**MANAGEMENT RESPONSE TO
REQUEST FOR INSPECTION PANEL REVIEW OF THE
KENYA: WATER AND SANITATION SERVICE IMPROVEMENT PROJECT
(P096367) AND WATER AND SANITATION SERVICE IMPROVEMENT
PROJECT – ADDITIONAL FINANCING (P126637)**

February 17, 2017

Figure 1: Schematic diagram of infiltration, wells, and tunnel, to show that the tunnel cannot block groundwater movement or replenishment.

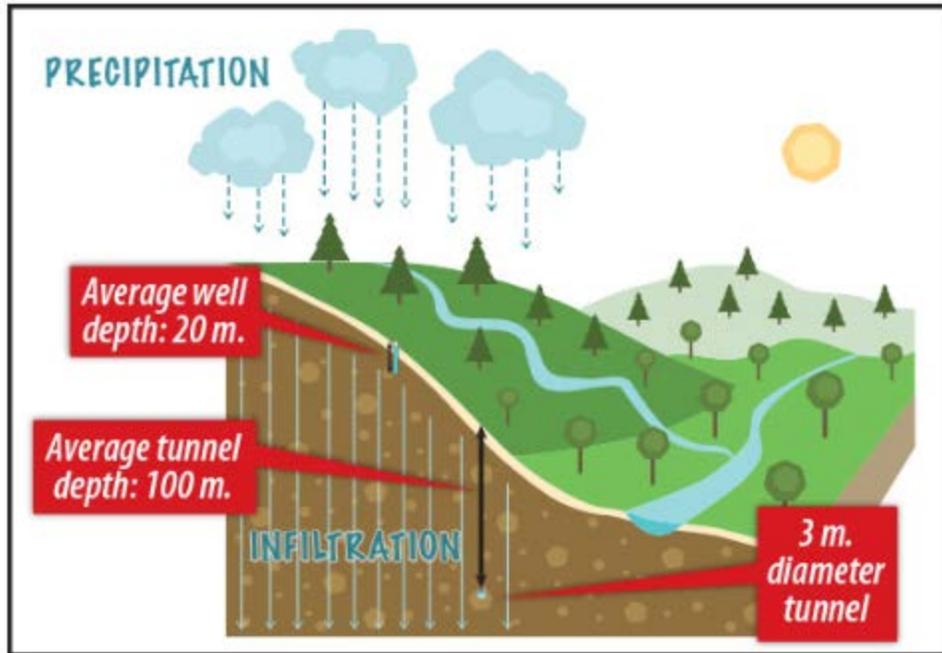
a. *Allegation: The environmental and social impact assessment for the NCT1 was not comprehensive and as a result, the NCT1 is being constructed without adequate geotechnical studies to map rocks, aquifers, water table, swamps, springs and associated mitigation measures. Tunneling will puncture aquifers, interrupt underground water flow paths and cause rivers and springs to dry up.*

26. ***Based on the comprehensive studies examining the project's potential impacts there are no indications that the NCT1 would cause adverse impacts to people living above the tunnel alignment.*** The design was informed by adequate geotechnical studies as described in Annex 1 (Items 8 and 43). It is not possible for the tunnel to interrupt groundwater flows, as alleged in the Request. Such groundwater flows occur over a large area, in the context of which the tunnel is a small obstacle that flows will pass around (see Figure 1 below). To avoid any water seepage into the tunnel, the entire tunnel will be lined with a watertight lining, following international best practice. Given that the tunnel will be fully watertight and grouted to the outside rock, it is not plausible that rivers or springs would "dry up" as alleged, nor can the NCT1 "puncture" aquifers.

27. **Management acknowledges that during construction, limited seepage into the tunnel may occur.** Measures to avoid any significant seepage during construction are part of the contract, such as grouting ahead of the tunnel face and measures to manage the potential impacts. There are monitoring programs for seepage into the tunnel during construction as well as for the water sources above the tunnel. In the unlikely event that wells above the tunnel are affected during construction, the AWSB would deliver water by tanker to the affected communities, as noted in the Environmental Management Plan. Once construction works are completed, it is expected that the water in these wells will be restored naturally when the aquifer returns to its original level following the next rains. In the interim, the AWSB has committed to ensure adequate water supply to the affected communities until affected wells are replenished.
